March 12, 2025  
SCS Project No. 16224067.00

Subject: City of Uvalde MSW Landfill - Uvalde County  
Municipal Solid Waste - Permit No. 1725  
Permit Modification Application – Landfill Gas Management Plan  
RN102803921 / CN600648455

In response to your June 30, 2024 email, the following summarizes the revisions made to the LGMP, as described below in response to your questions/comments:

FIGURE 1.4

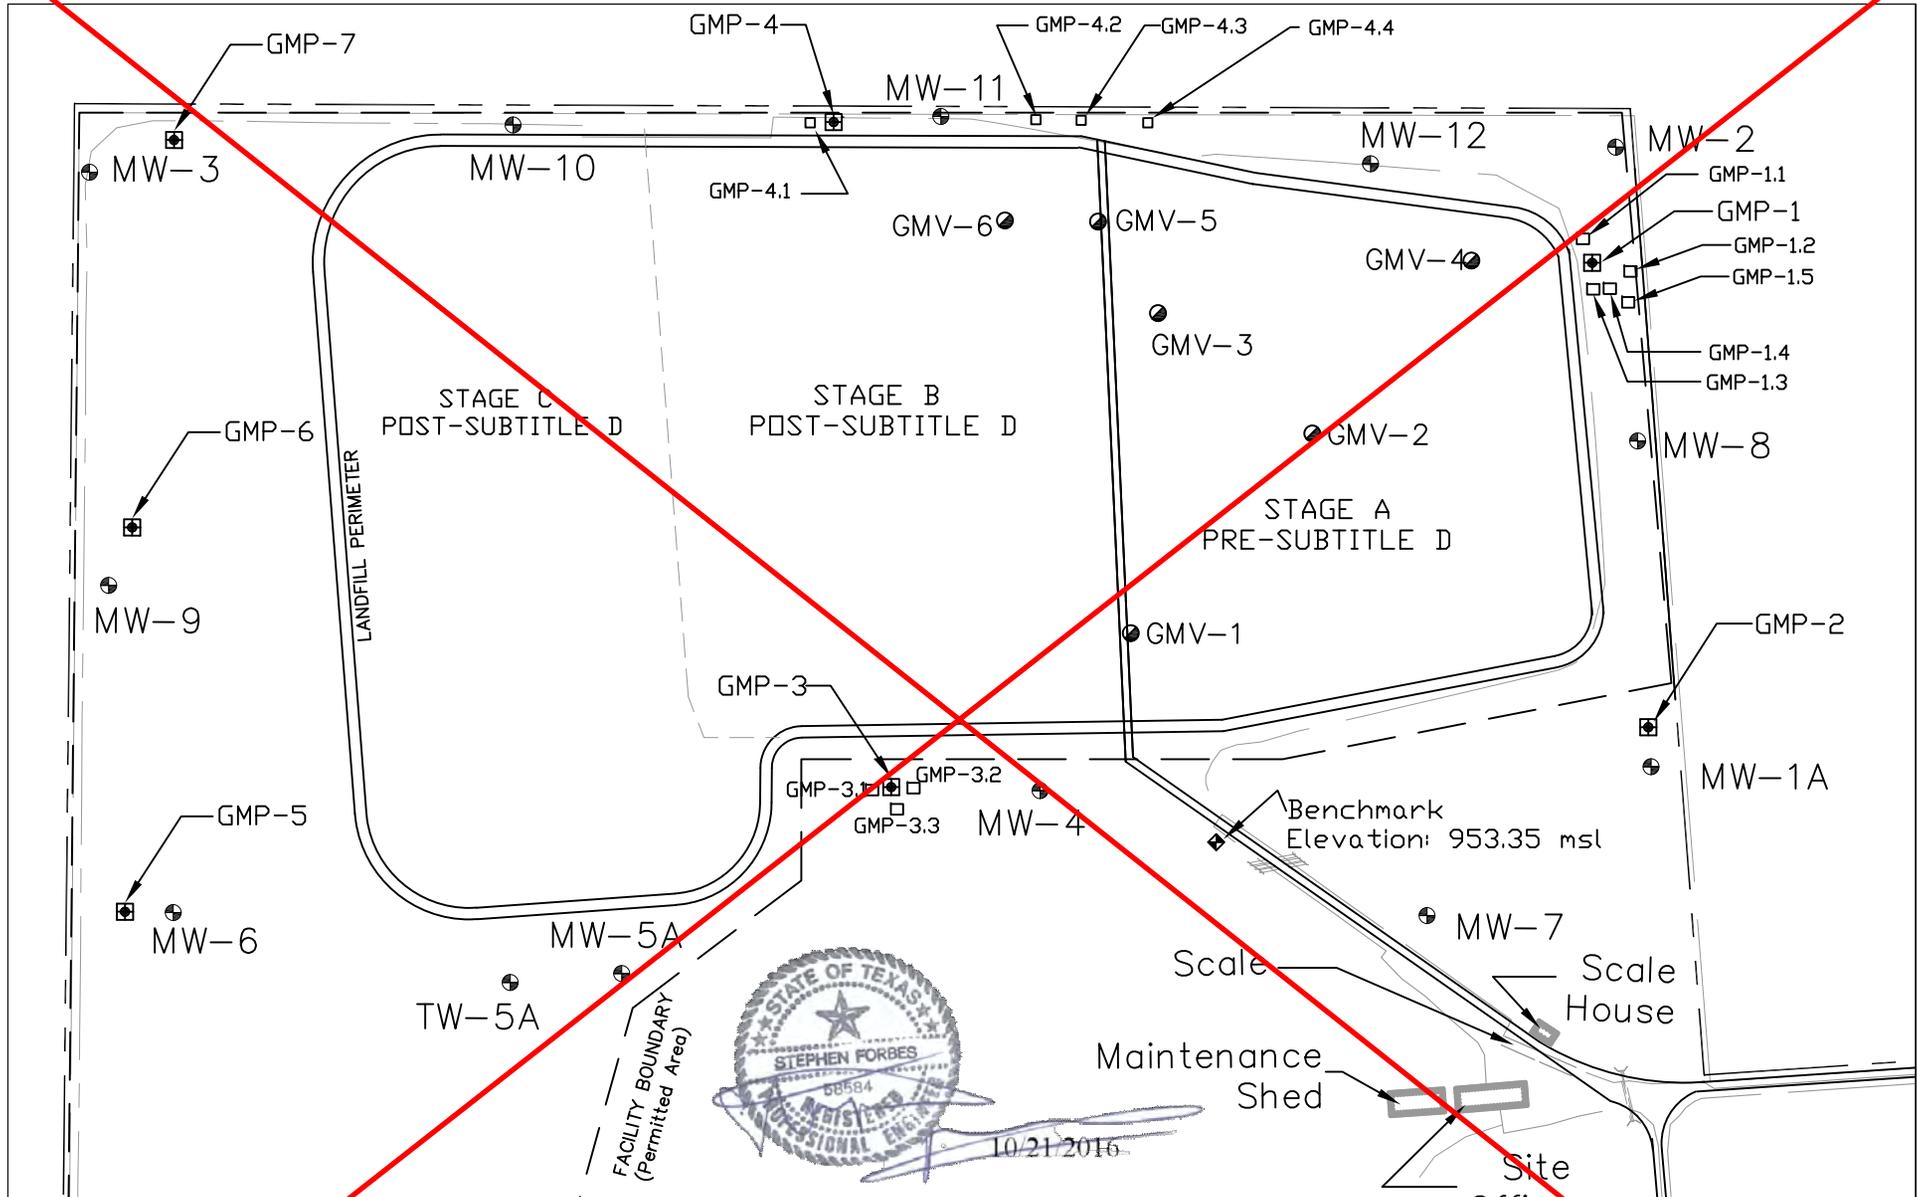
A14a. [Figure 1.4] Just FYI right now:  
MW-11, Jan 2023 cis-1,2-dichloroethene detected; not yet resampled.

A14b. [Figure 1.4] Just FYI right now:  
MW-12, Initial detections of benzene and cis-1,2-dichloroethene in July 2022; not detected in verification resamples.

A15. [Figure 1.4] Would be good to have gas probe here, between waste unit boundary and facility structures outside permit boundary.

A16. [Figure 1.4] Is MW-7 checked for methane? May not be useful as it is likely completed at depths below zones of potential gas migration.

A17. [Figure 1.4] Do structures have continuous gas monitors?

A18. [Figure 1.4] Modify monitoring point labels to be consistent with current terminology.

***The structures do not have continuous gas monitors. Please refer to the response to comment A8b.***

***Figure 1.4, General Landfill Facility Layout, has been removed and the information is incorporated into the updated and replaced Figure 3.1, Gas Monitoring Features Location Map. The monitoring point labels have been updated for consistency in the replaced Figure 3.1.***

FIGURE 3.1

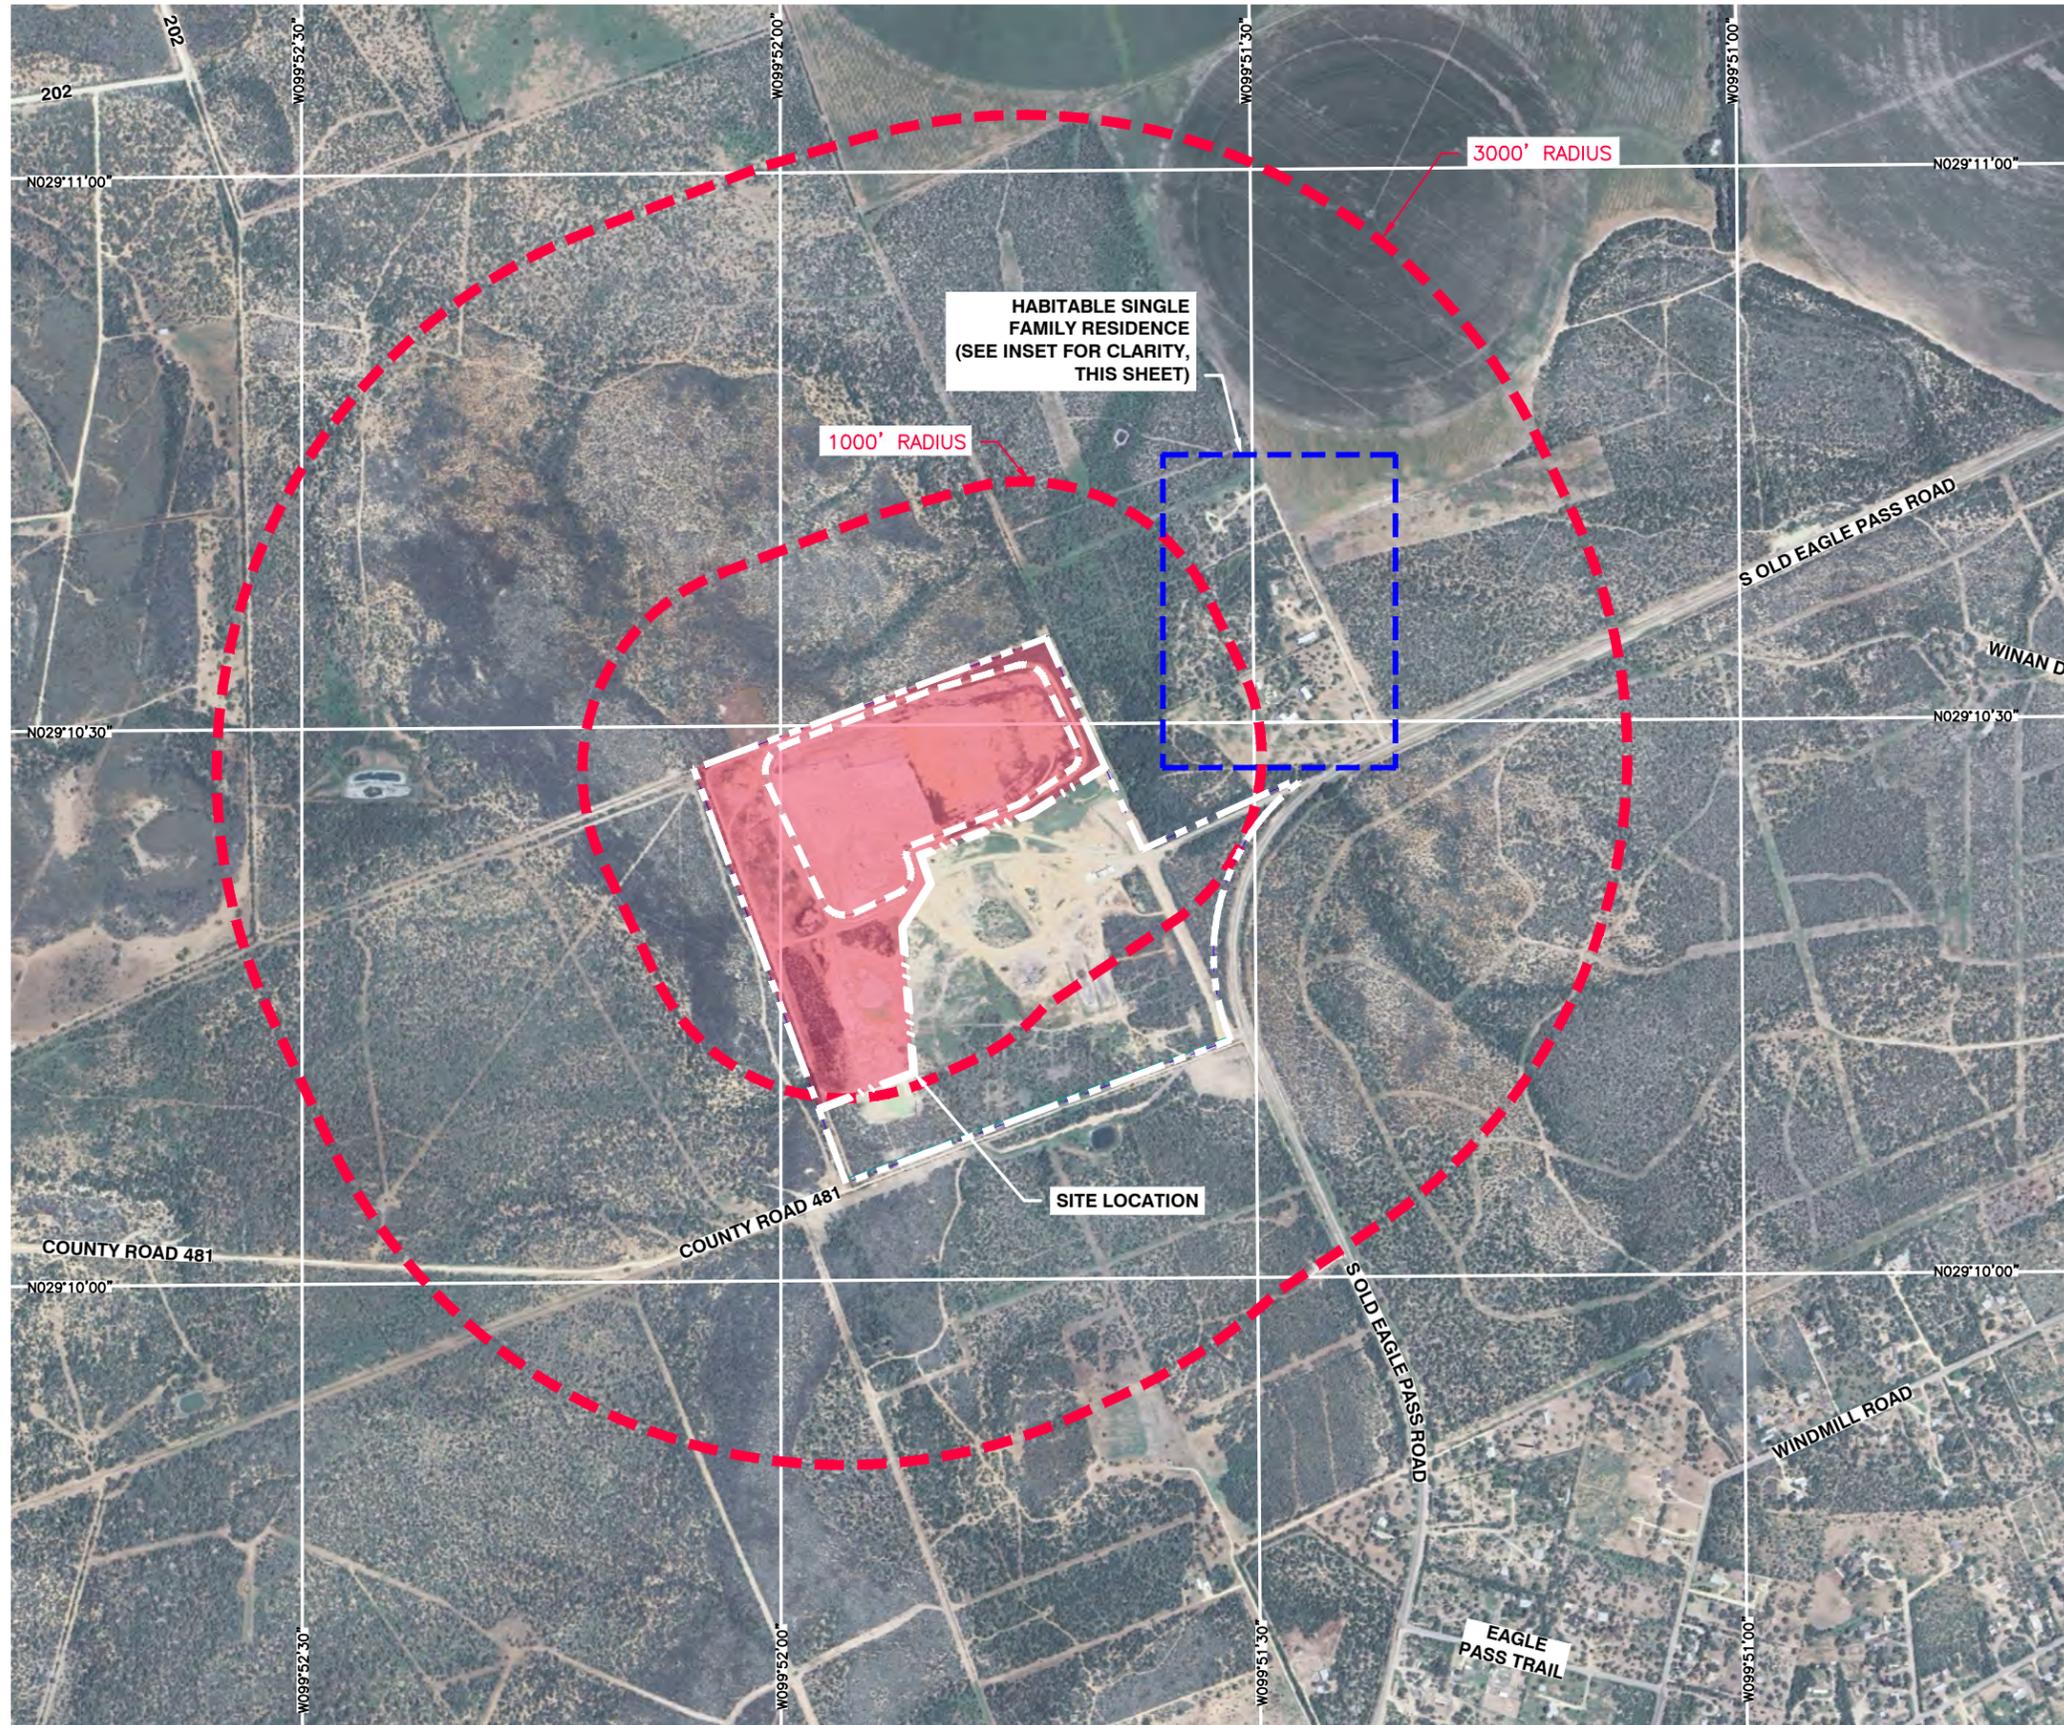
A19. [Figure 3.1] Replace with drawing showing all of the gas monitoring and management features. Label monitoring point consistent with current terminology.

***Figure 3.1, GMP & GV Location Map, has been renamed Gas Monitoring Features Location Map and replaced with an updated map of the current gas monitoring system and features, including the general facility layout information previously shown in Figure 1.4, General Landfill Facility Layout, as well as updated terminology.***
